May 30, 2017

Re: CSO Order on Consent (DEC Case No. CO2-20110512-25,
modification to CO2-20000107-8)
Section IV.A.2, City-Wide Green Infrastructure
Implementation, Green Infrastructure Performance Metrics
Report
Section IV.A.3, City-Wide Green Infrastructure
Implementation, Green Infrastructure Contingency Plan
Response to DEC Comments Dated March 16, 2017

Schematic of Connected v. Managed Impervious Area for GI Assets

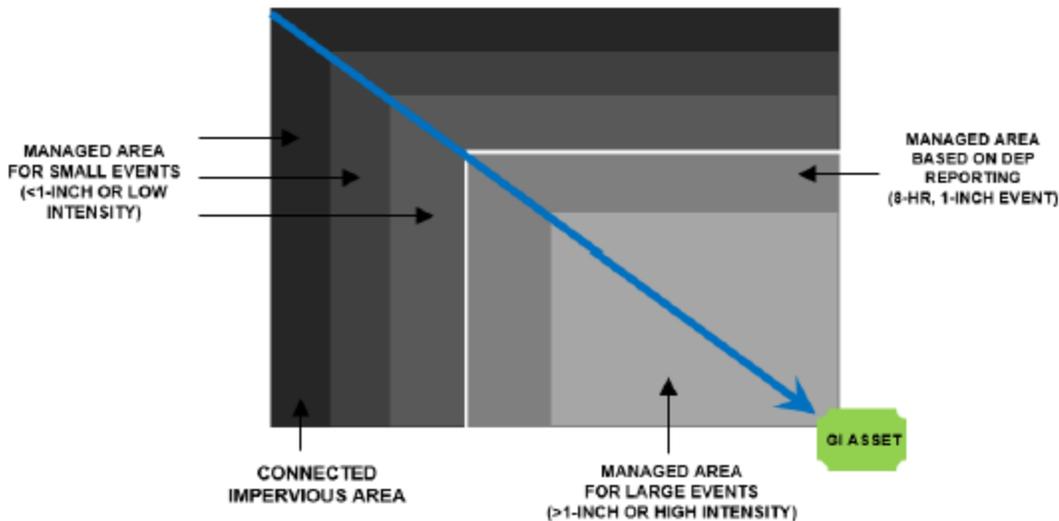
DEC Comment #3: [a] Section 4.4, the wording of the 4th paragraph is confusing. [b] Also in Section 4.4, last paragraph, the City indicates that the infiltration rates for future GI are based on average values for nearby constructed ROWBs. Confirm if the City also uses soil maps when estimating infiltration rates for future ROWBs.

[a] For the purposes of distributed modeling of the GI assets under the 1.5% GI modeling scenario, the actual connected impervious tributary area was used in the InfoWorks model, which was defined via a GIS analysis for each GI asset with known location based on local topography, street slopes, and relative locations of catch basins. In most cases the actual connected area is greater than the managed area reported by the City using a "static" 1-in, 8-hour precipitation event. During the dynamic continuous model simulations for the typical hydrological year (2008 JFK International Airport's NOAA rain gauge), runoff from this entire connected impervious area had the ability to reach the GI assets for a large number of precipitation events smaller than 1 inch. This concept is illustrated in Figure 1-4 of the PM Report, and is also included below. As a result, the impervious area managed "dynamically" over the typical year is always greater than the "static" value for a 1-in, 8-hr event reported by the City. For consistency with the City's annual GI reports, the "static" value was utilized to determine the managed impervious area, which was reported in the PM Report.
